CMB Meeting Minutes #172

REFERENCE Project No. M544.1, Contract No. 149 Task 1-8.02

SUBJECT: Configuration Management Board Meeting # 172 – Rev. No. 0

Phase 1

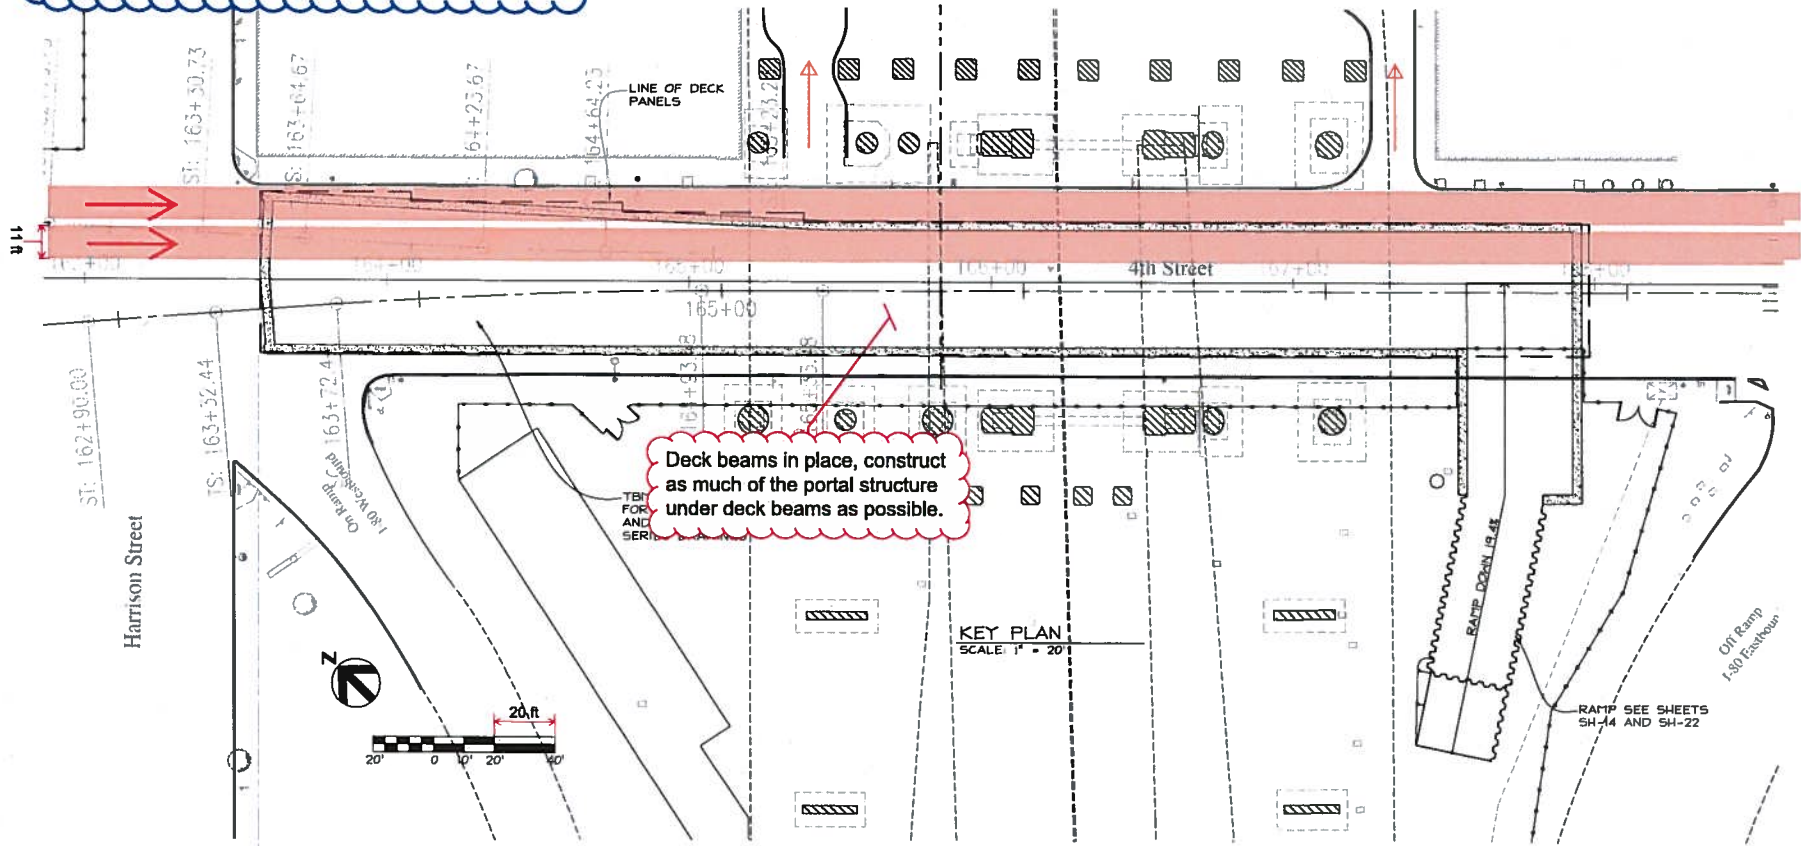
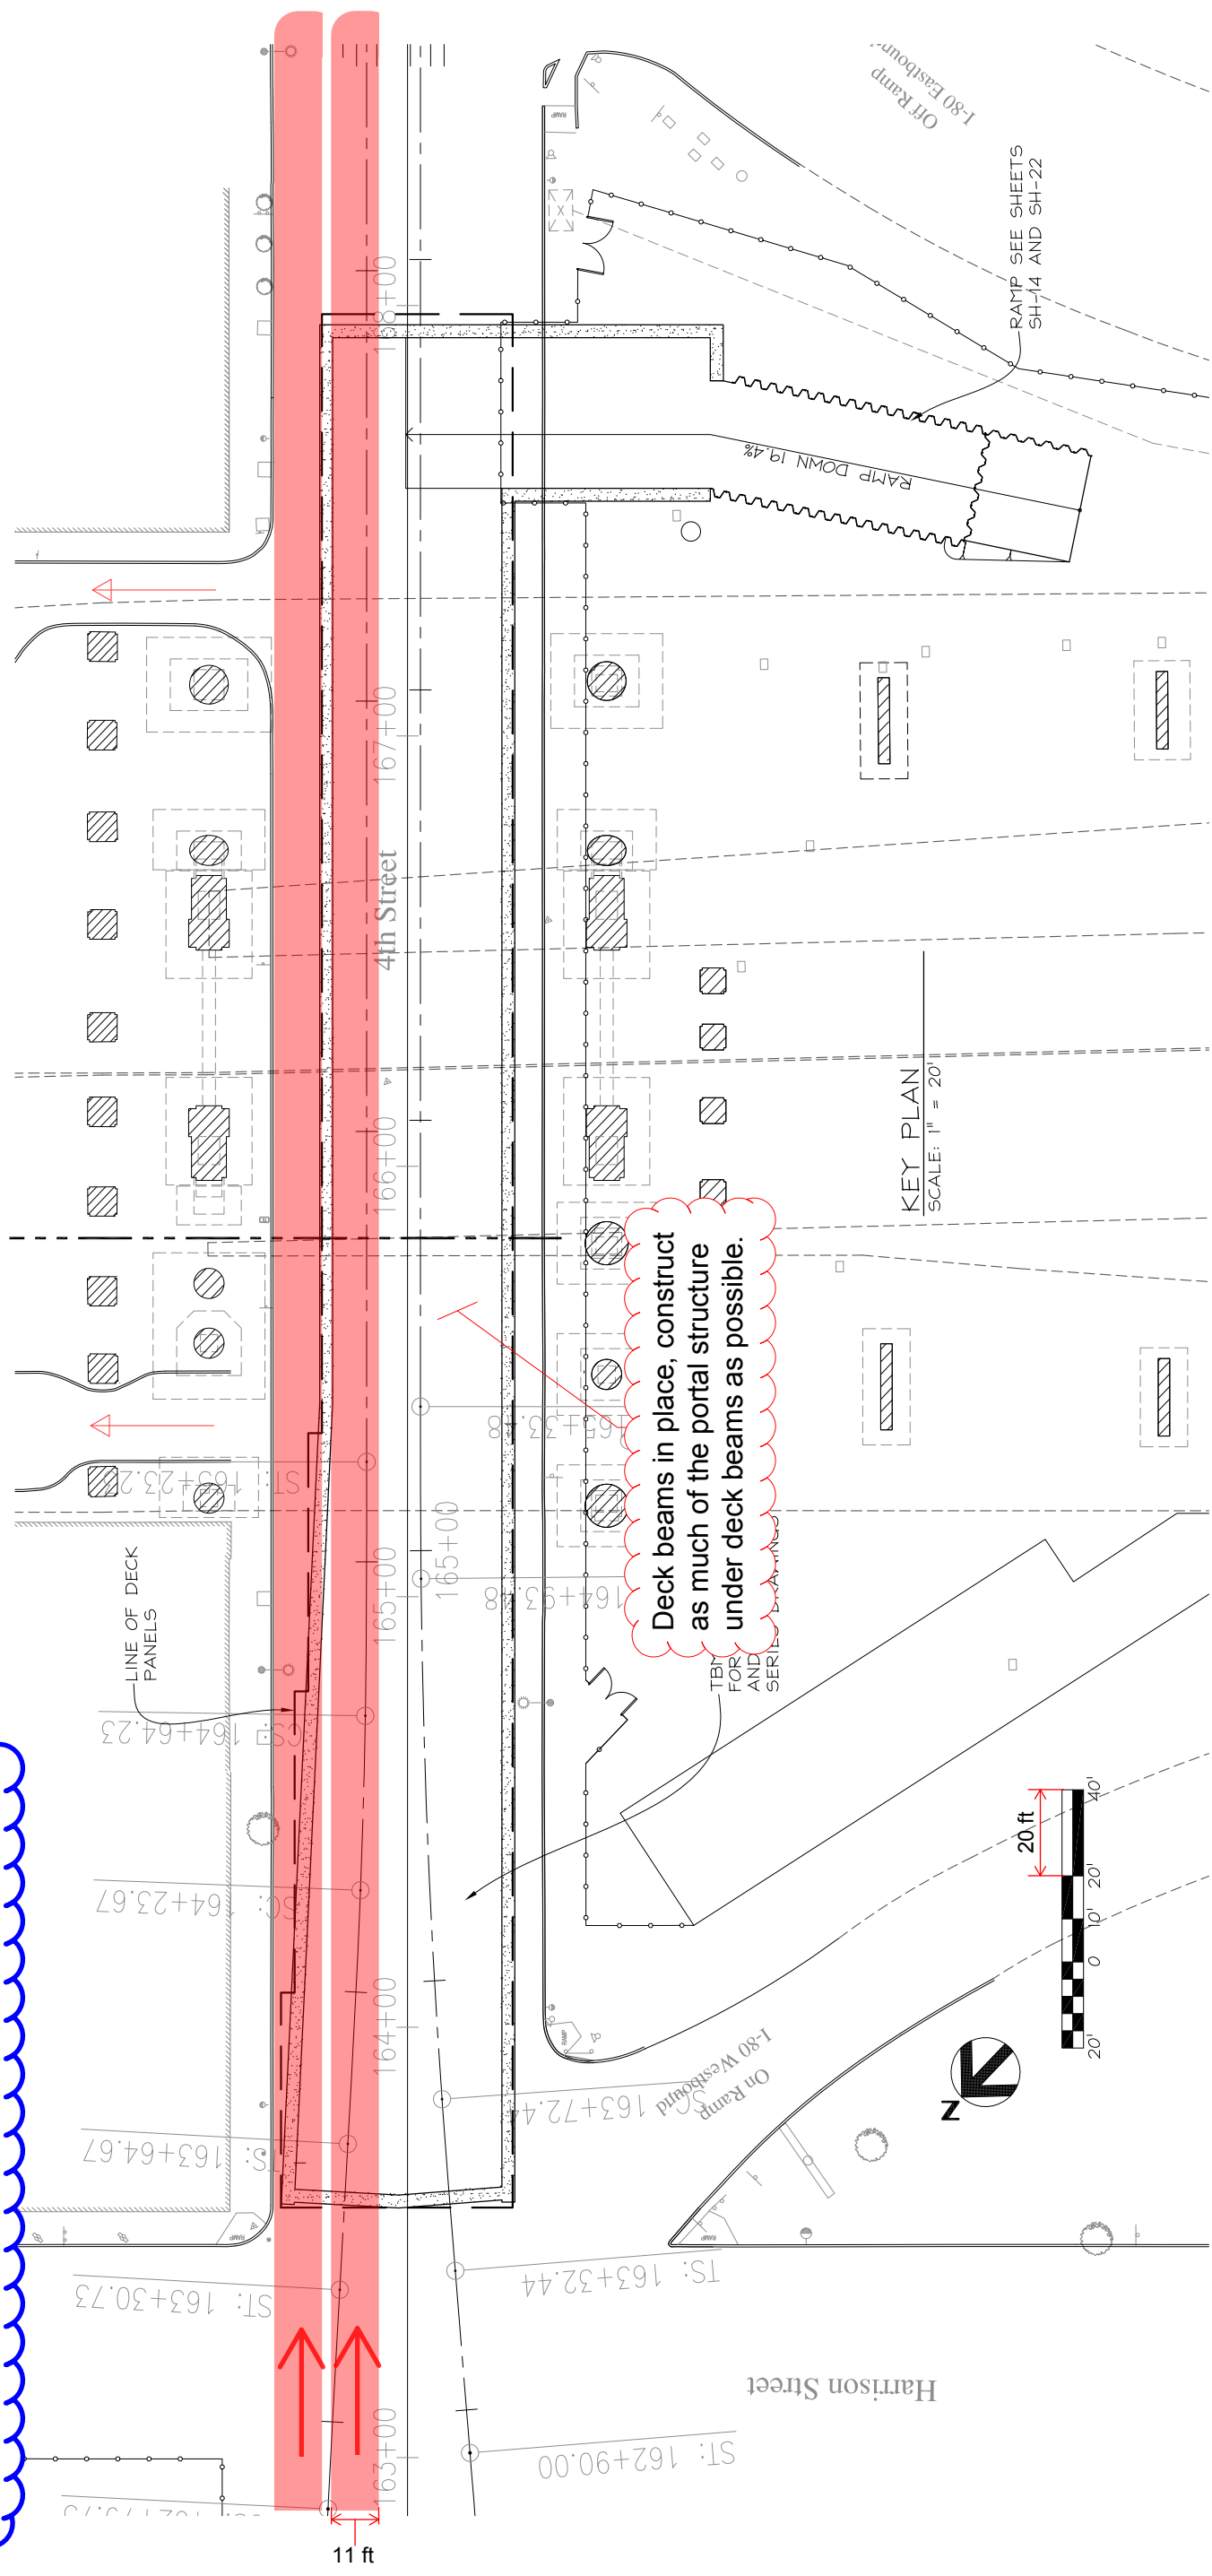
ITEM #	DISCUSSION	ACTION BY DUE DATE
1-	A. Clifford presented for discussion conceptual diagrams for 3 phases of traffic realignment for the proposed full closure of 4th Street for portal construction from October to December 2014. The planned closure would cause disruption to Golden Gate (GG) transit bus depot and would require GG transit’s approval as sign off to the potential two to four month closure. Phase 2 options proposed for traffic during the full closer are option 1 - Perry west only, route traffic through, parking lot on to Stillman, option 2 - Two-way traffic on Perry and Stillman. Phase 3 would present the biggest difficult for GG transit buses during the AM pull in. The Contractor has offered to resend their claim for the woodpiles as a compromise to SFMTA if allowed to proceed with the full closer of 4th Street. The Contractor has also offered to clean up GG transit’s lot of dust build up. CMB suggested a meeting be scheduled with DPT to discuss this issue (see attached).

- Two Lanes East Open
- Present Until End of Baseball Season / Late October

Phase 2

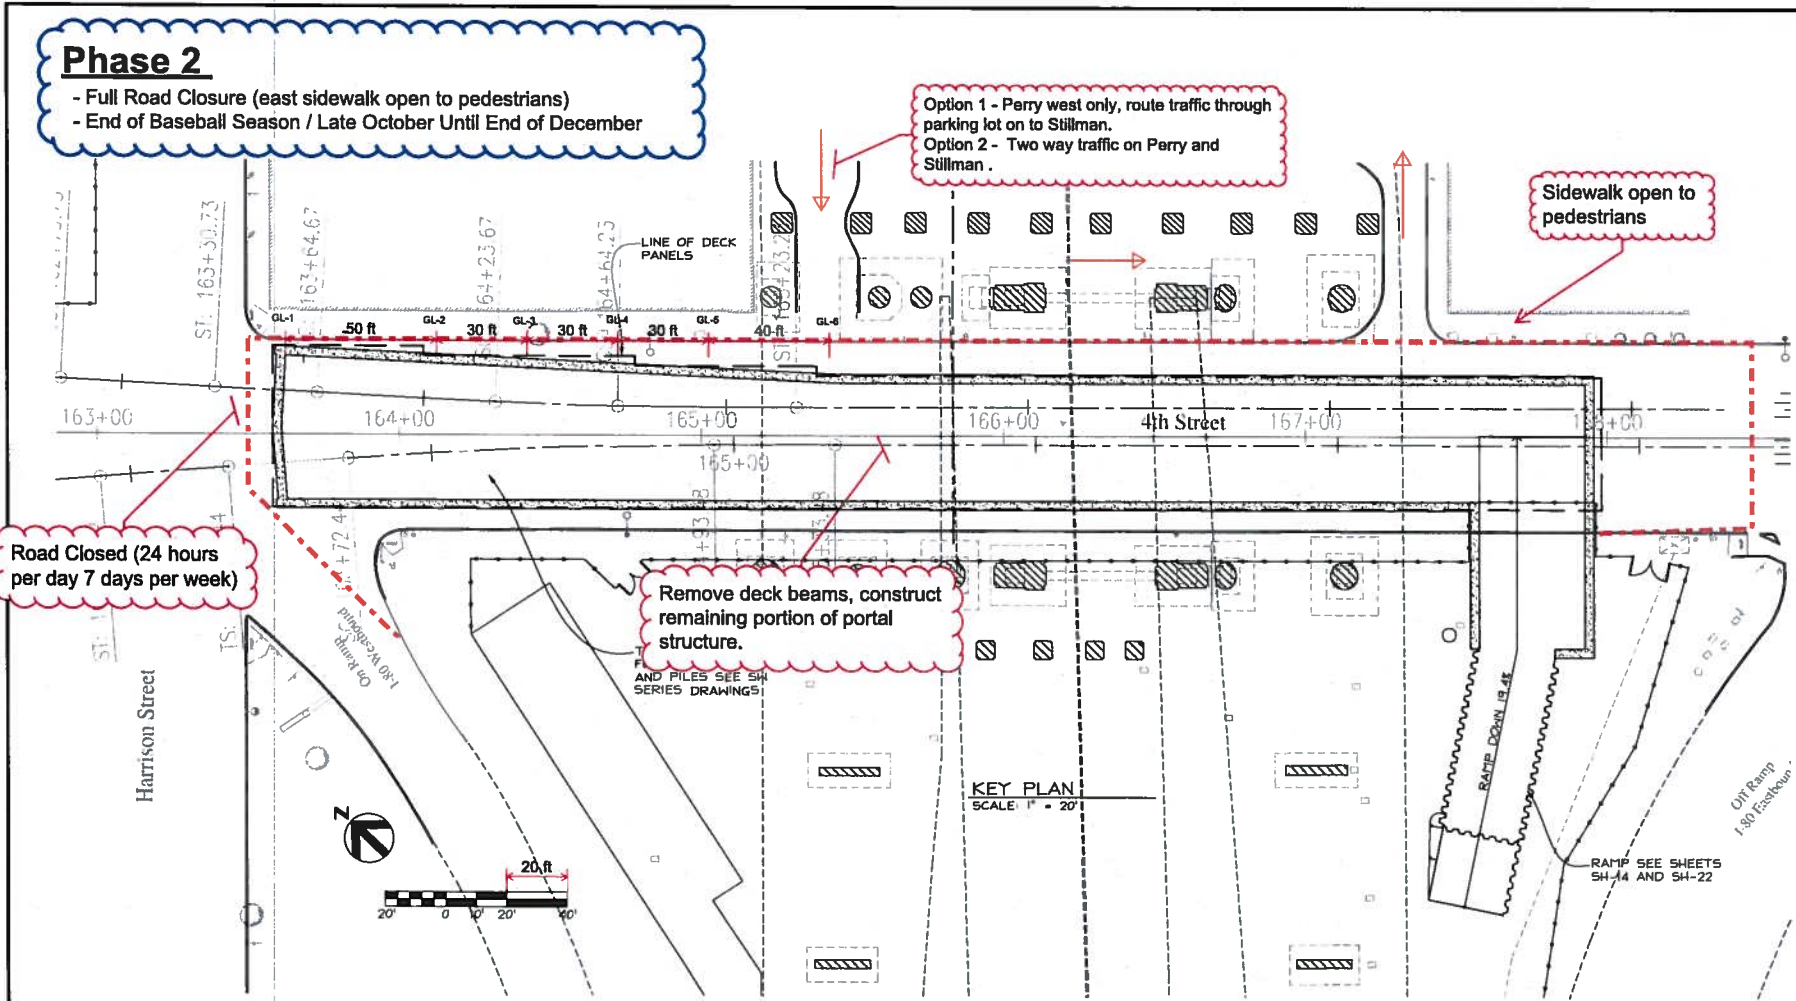
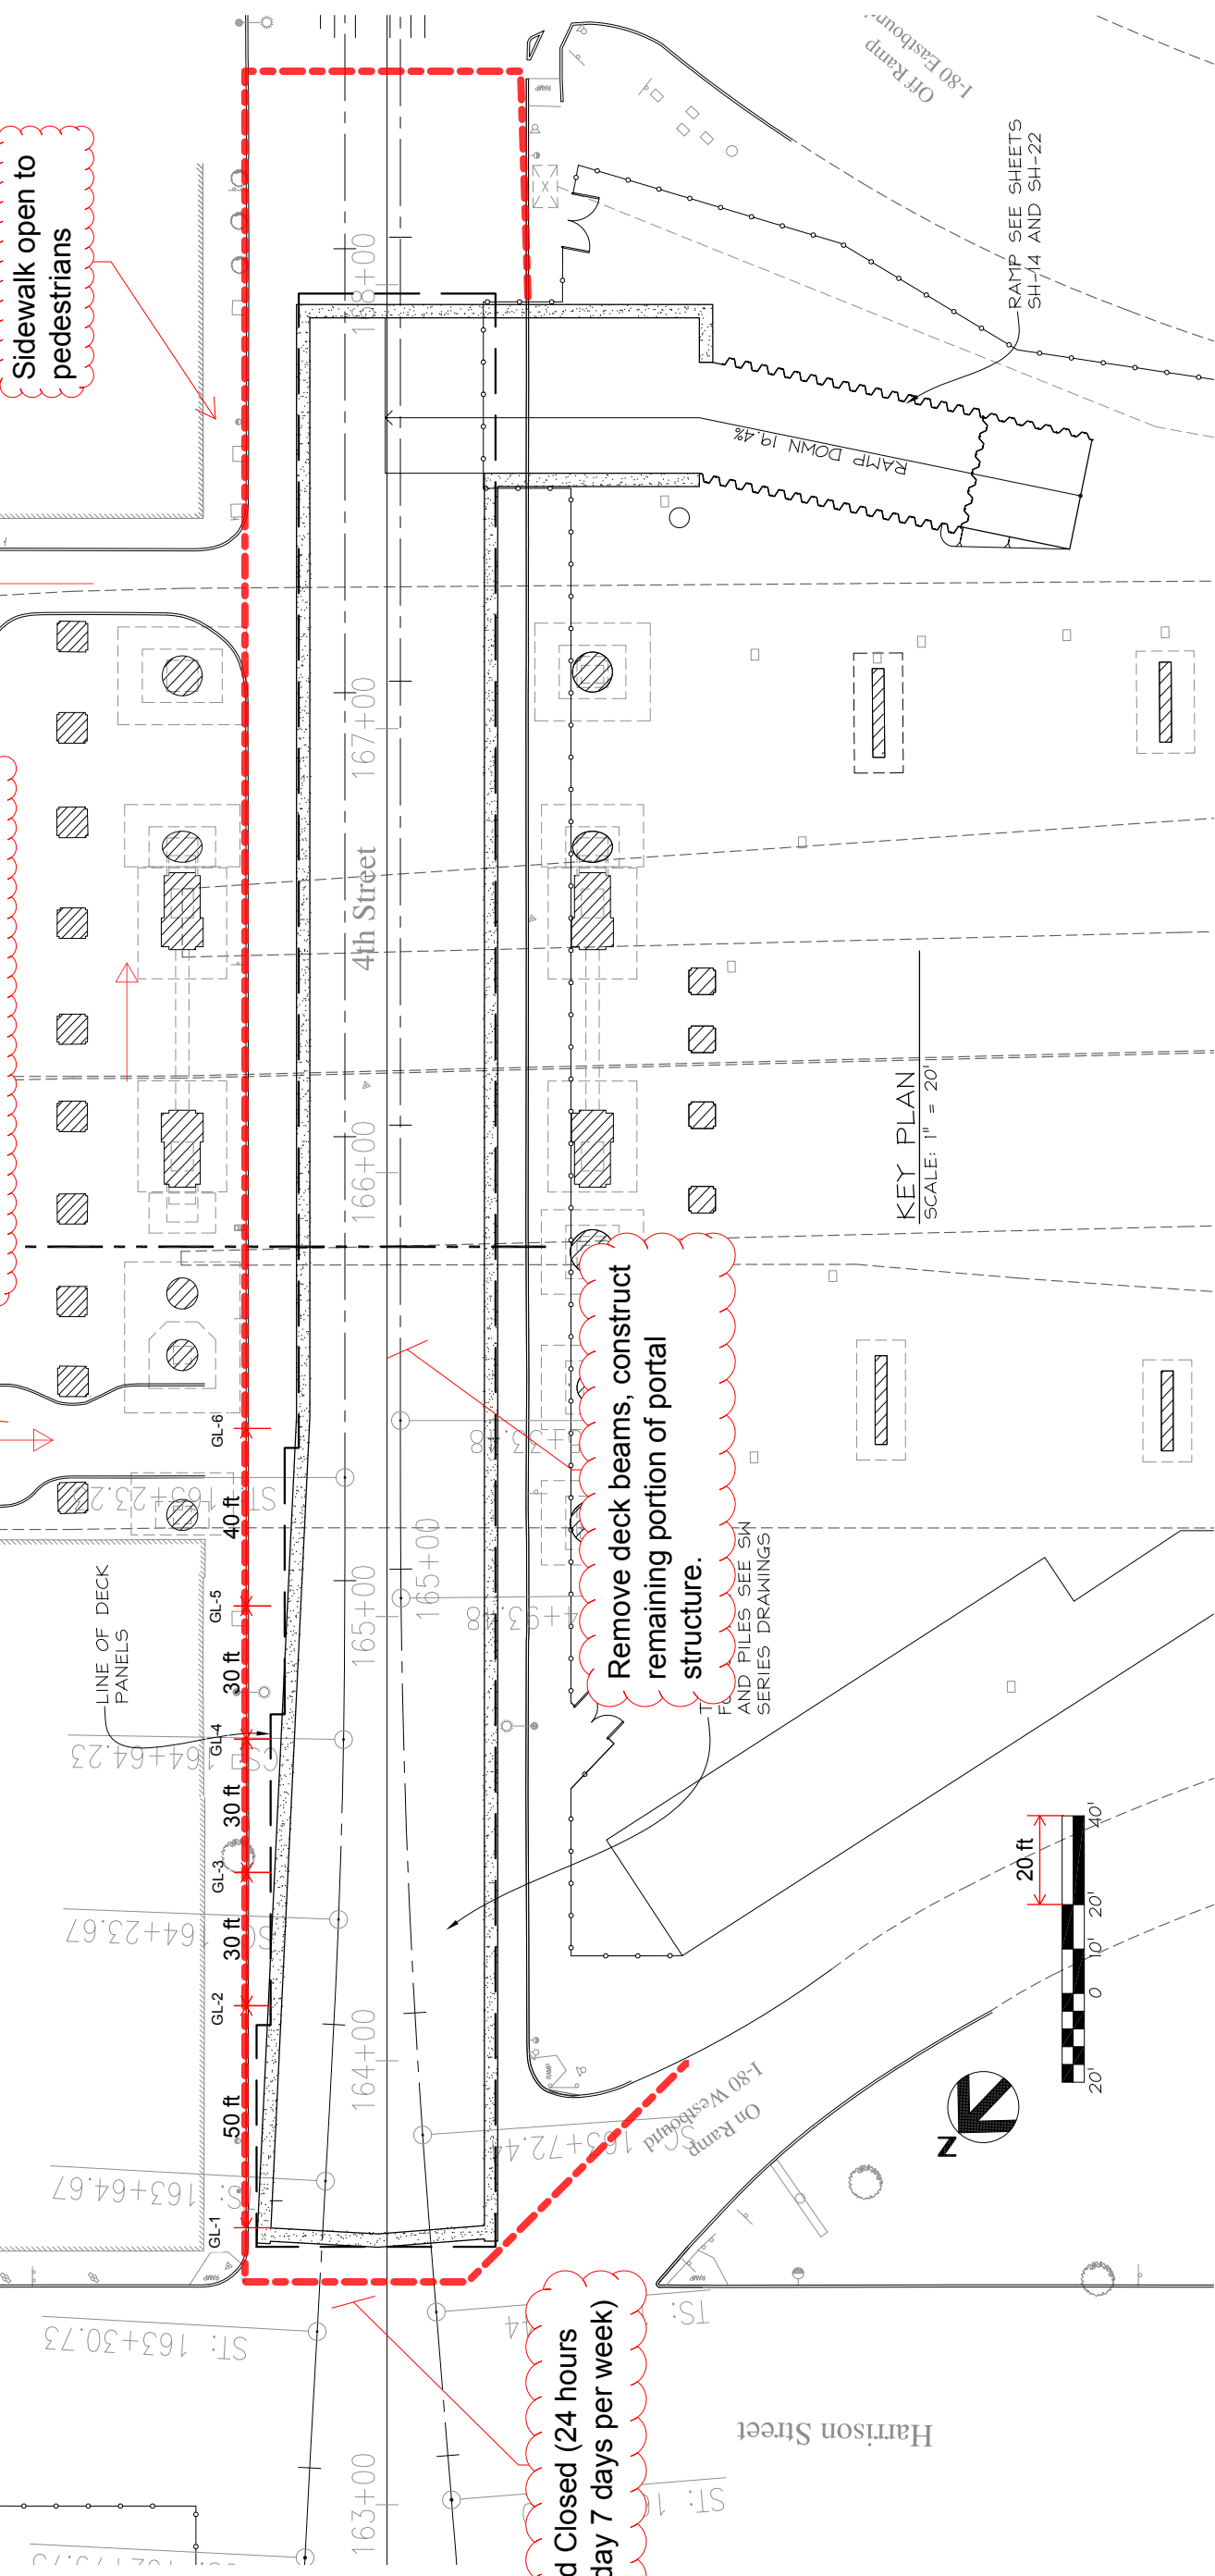
- Full Road Closure (east sidewalk open to pedestrians)
- End of Baseball Season / Late October Until End of December

- Option 1 - Perry west only, route traffic through parking lot on to Stillman.
- Option 2 - Two way traffic on Perry and Stillman.
